ADDENDUM NO. 1 TO 19-0059-4

FOR: QUACCO ROAD AT SR 25 / US 17 INTERSECTION IMPROVEMENTS

Addendum #1: Quacco Road at SR 25/US 17 Improvements

TYPICAL SECTION #3
QUACCO ROAD
STA 217+24.00 TO STA 220+35.00

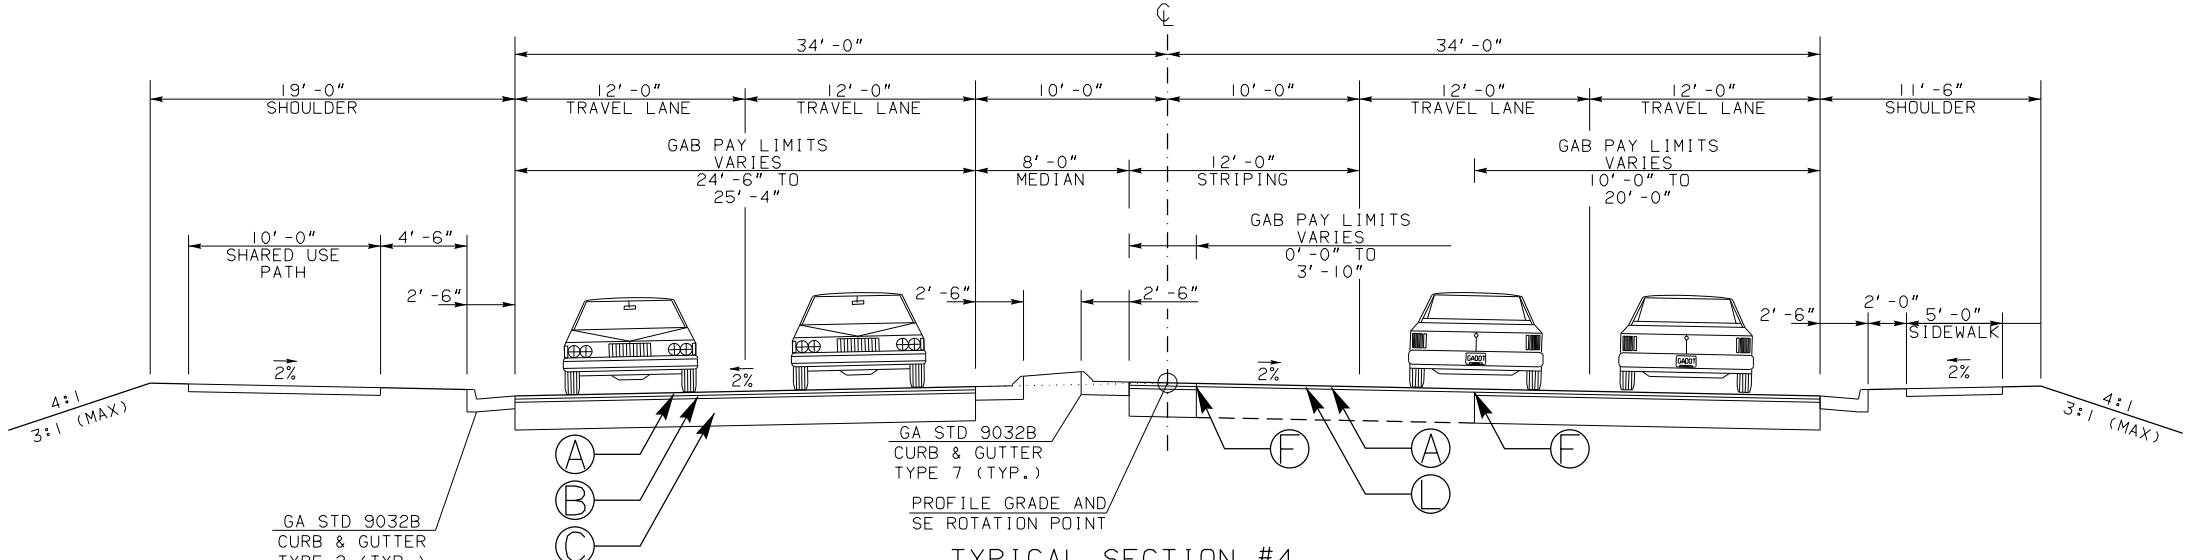
5. Typical section #3 has a callout for "D" which is not listed in the pavement design. Please clarify.

10. ***On Drawing 05-002 Typical Section #3 identifies a “D” in the pavement design. Was this intended to be “L” for leveling?***

Typical Section #3 revised "D" to "L" for asphaltic concrete leveling required.

Typical section #3 revised “D” to “L” for asphaltic leveling required.

REVISION DATES			TYPICAL SECTIONS SR 25/US 17 AT QUACCO ROAD INTERSECTION IMPROVEMENTS			
06/19/19						
			CHECKED:		DATE:	
			BACKCHECKED:		DATE:	
			CORRECTED:		DATE:	
			VERIFIED:		DATE:	
						DRAWING No.
						05-0005

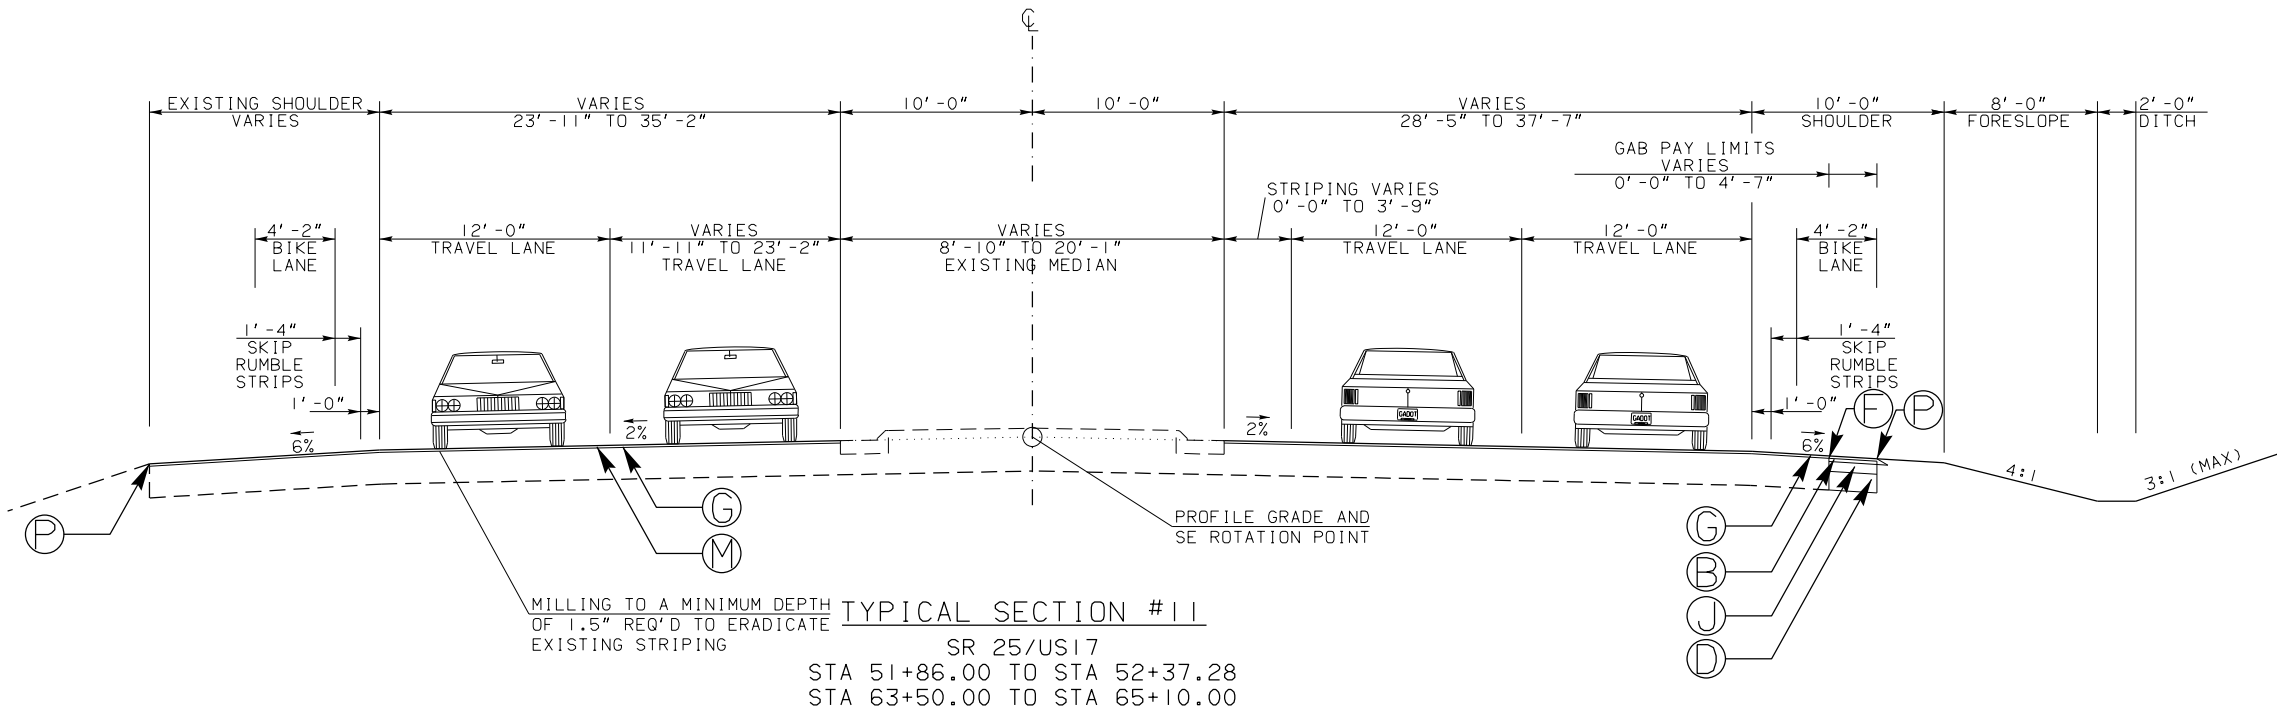
4. Please clarify what the intent is for widening on Highway 17. The typical sections show variable width full depth widening (12"+6"+2"+1.5") while the cross sections for this area show full depth widening as well as shoulder paving with a different sectional depth.

The intent at this location is to show variable width full depth widening (14"+6"+2"+1.5") with full depth paved shoulders. Cross sections and typical sections have been revised to clarify.
